VNI West PADR Submissions

Regulatory Investment Test for
Transmission

Summary of stakeholder feedback on
the PADR

Figure 1 PADR and PACR approaches to presenting avoided generation/storage costs (excluding fuel costs), Option 3A (Step Change scenario)

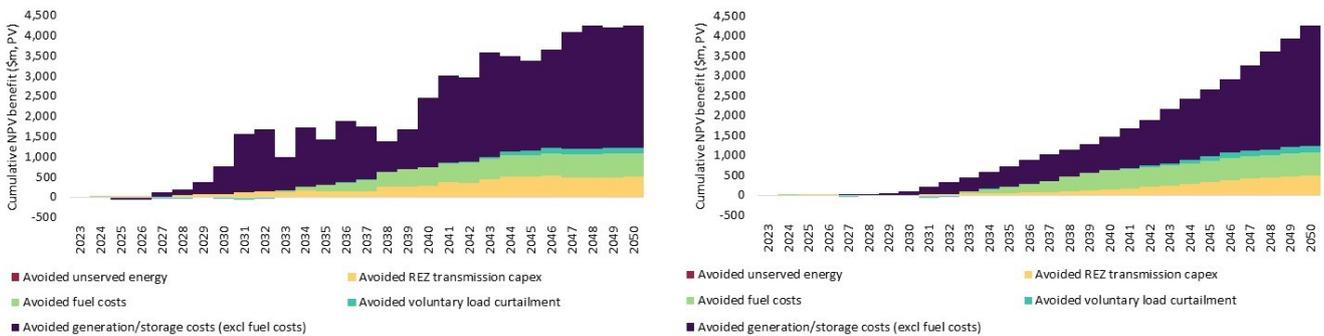
AVP and Transgrid note that there was an apparent misinterpretation of the PADR results in some points raised in submissions. Specifically, all charts in the PADR showing the breakdown of cumulative gross benefits for Option 1 presented the entire capital costs of these plant in the year avoided to highlight the timing of the expected market benefits capacity difference (despite the generator and storage capital costs actually being included in the market modelling on an annualised basis). This was purely a presentational choice to assist with relaying the timing of the expected benefits capacity difference (for example, coincident with when thermal plant retire or transmission augmentations are commissioned) and did not affect the overall estimated net benefit of the options⁶⁴. An impact of this presentational choice, however, was that when considering cumulative benefits over the study period, it made it appear that more of these benefits were accruing earlier in the assessment period than if the results were presented on an annualised basis.

In light of this, AVP and Transgrid have revised the presentation of these types of charts to present these benefits on an annualised basis (which is also how they are presented in the ISP). This also allows a more like-for-like comparison of investments in different asset types with different economic life.

Figure 1 presents the breakdown of cumulative gross benefits for Option 3A under the *Step Change* scenario presented in the Consultation Report on the options using both the approach applied in the PADR (on the left-hand side) and the annualised approach applied now/for the PACR (on the right-hand side). It shows that:

- The pattern of avoided generation/storage costs (excluding fuel costs) differs across the two approaches, with benefits appearing to accumulate more gradually under the annualised approach.
- The choice is purely presentational and that, irrespective of the approach applied, the same cumulative gross benefits are reached by the end of the period (in present value terms).

Figure 2 Snowy Hydro scheme topology

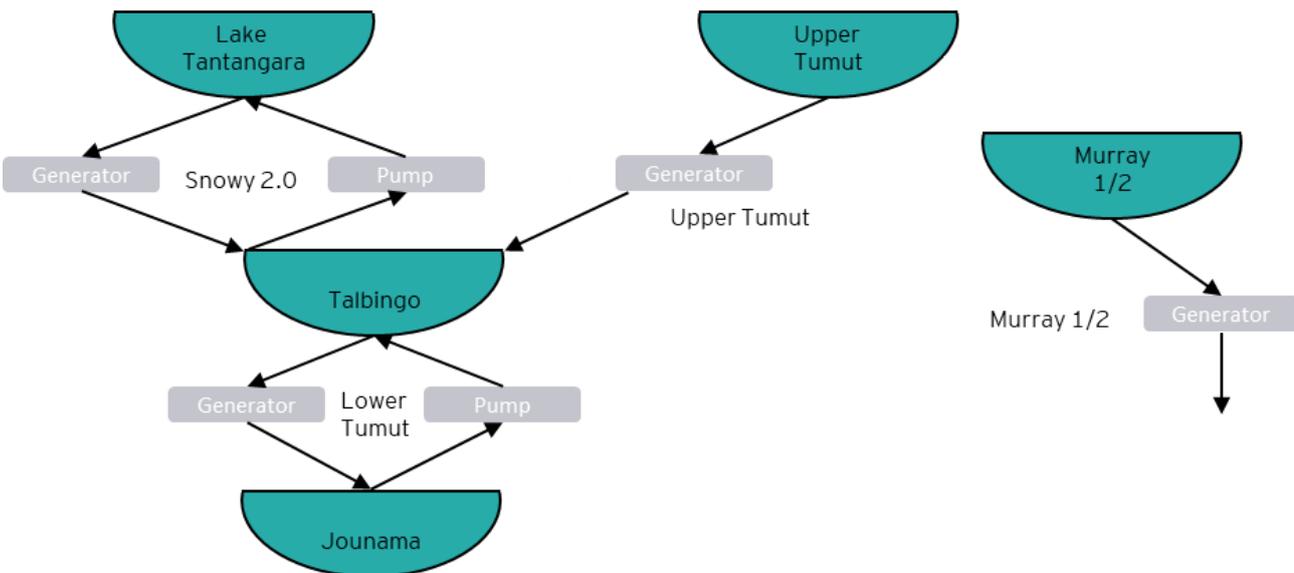
Some stakeholders expressed concern with the modelled operation of Snowy 2.0 in the PADR and the estimated benefits from VNI West to ‘unlock the full potential of Snowy Hydro 2.0’. Ted Woodley, Bruce Mountain and Simon Bartlett all contended that the assumed operation of Snowy 2.0 is substantially overstated in the PADR analysis and hence so is the associated benefit of VNI West.

Figure 2 below shows the modelled Snowy Hydro scheme in the market modelling, which is the same as the 2021 IASR representation.
